January 22, 2016

Project No: 141-21811-00

**RE: R.M. OF MACDONALD - COMMUNITY OF SANFORD
WASTEWATER STABILIZATION POND EXPANSION
ENVIRONMENT ACT PROPOSAL – FILE No: 1921.10**

SHEET NUMBER:	C02
ISSUE:	2 OF 3
TAC RESPONSE	0
DATE OF: 2016/01/22

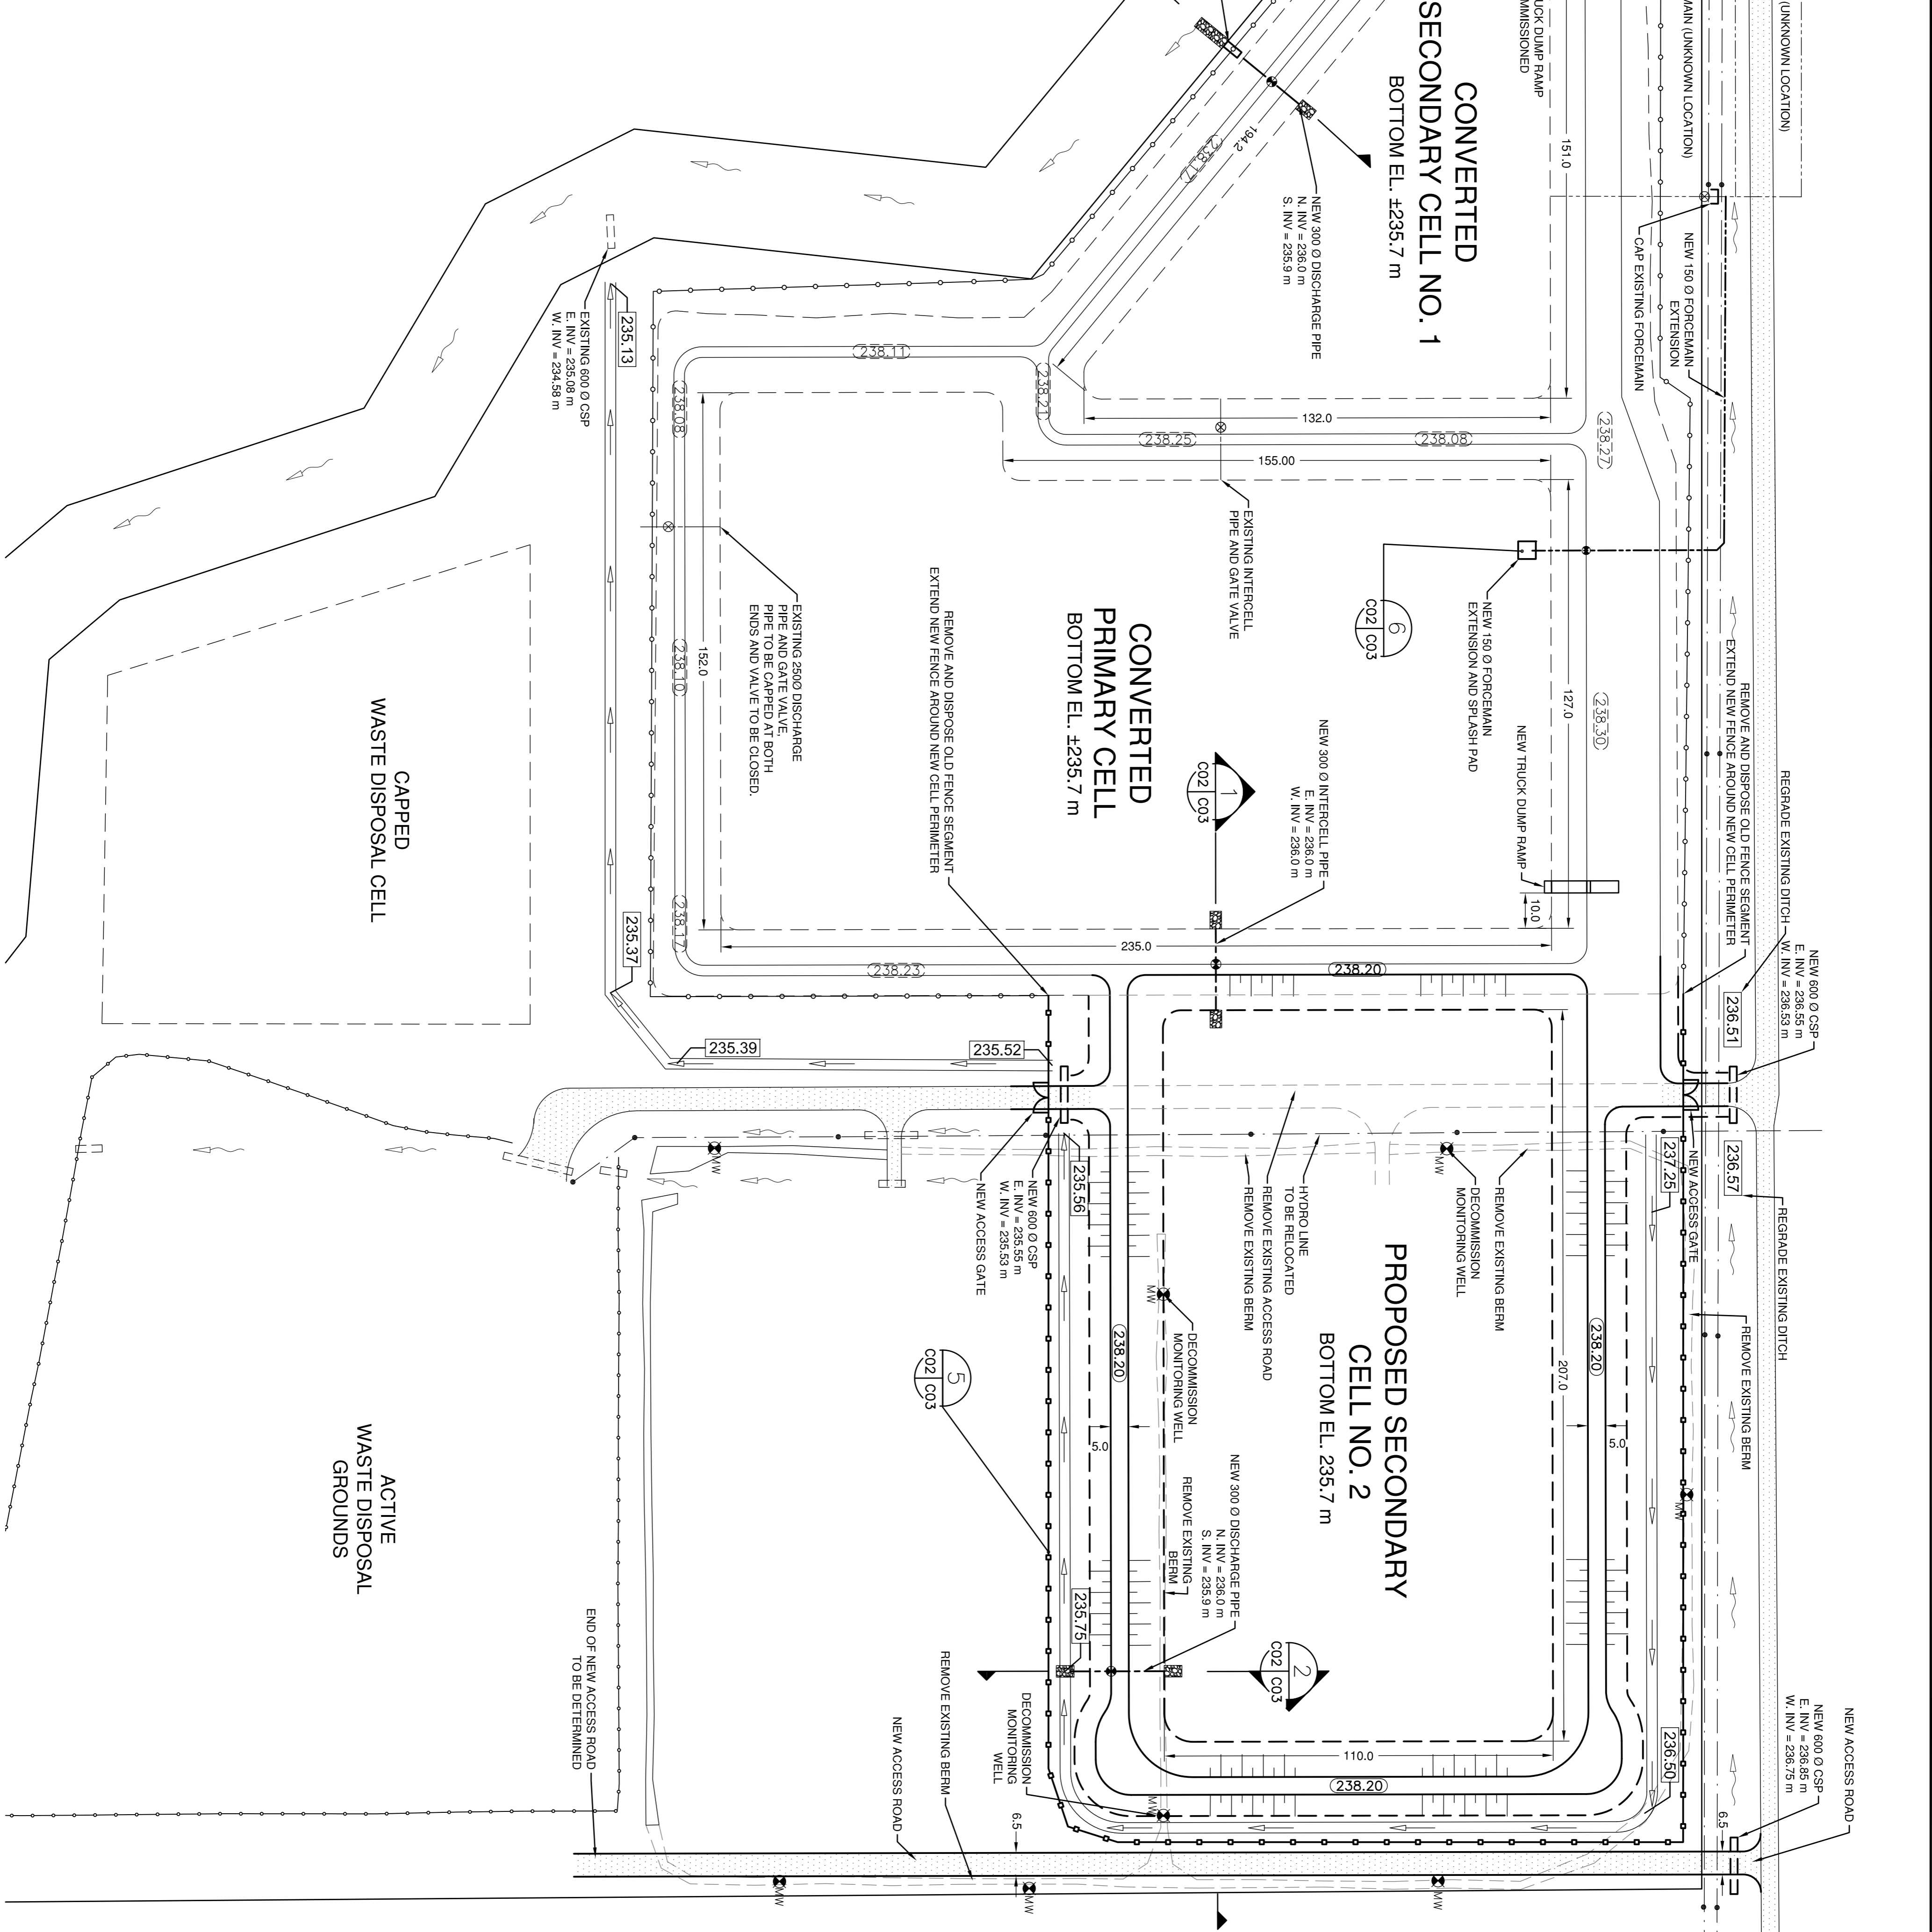
A. Decommissioning Plan for Existing Truck Dump Ramp

The condition of the clay liner around and underneath the existing truck dump ramp is unknown at this time. From the review conducted by WSP during the spring of 2015, the dyke slope around the truck dump ramp is partially eroded and therefore the clay liner is potentially eroded as well. We propose the following actions to decommission the existing truck dump ramp and to satisfy the requirement of a 1 m clay liner.

C. Decommissioning Plan for the Existing Discharge Pipe and Gate Valve at the South End of the Existing Secondary Cell

D. Splash Pad Details

E. Thrust Block Details

F. Installation of Inter-Cell Pipes

During the construction of the expanded lagoon, the existing primary cell will be lowered, exposing the area around the truck dump ramp. At that time, the truck dump ramp and all associated material will be removed and disposed and the existing clay liner will be reviewed to determine the depth of this liner. The partially eroded dyke slope will then be repaired to a 4H:1V slope utilizing the high-plasticity clay.

The attached engineering drawings C02-ISS2 and C03-ISS2 have been updated with the location of the existing truck dump ramp, as well as the liner information for the existing primary and secondary cells.

The existing south discharge pipe will be capped on both ends of the pipe and the valve will remain in a closed position. Drawings C02-ISS2 and C03-ISS2 have been updated accordingly.

Drawings C02-ISS2 and C03-ISS2 have been updated accordingly.

All new gate valves are supported by a 600 mm x 600 mm x 150 mm concrete block. Drawings C02-ISS2 and C03-ISS2 have been updated accordingly.

The new inter-cell pipe connection will be installed similarly to any new pipe installation. A trench shall be excavated and the bottom of the excavation shall be maintained in a condition to permit the proper installation of the pipe. Once the piping and gate valve are installed to specification, clay bentonite is placed and compacted a minimum of 150 mm around the new piping where it passes through the 1 m clay liner, and the trench is backfilled with clay material and compacted in 150 mm lifts to 95% Standard Proctor dry density. Drawings C02-ISS2 and C03-ISS2 have been updated accordingly.
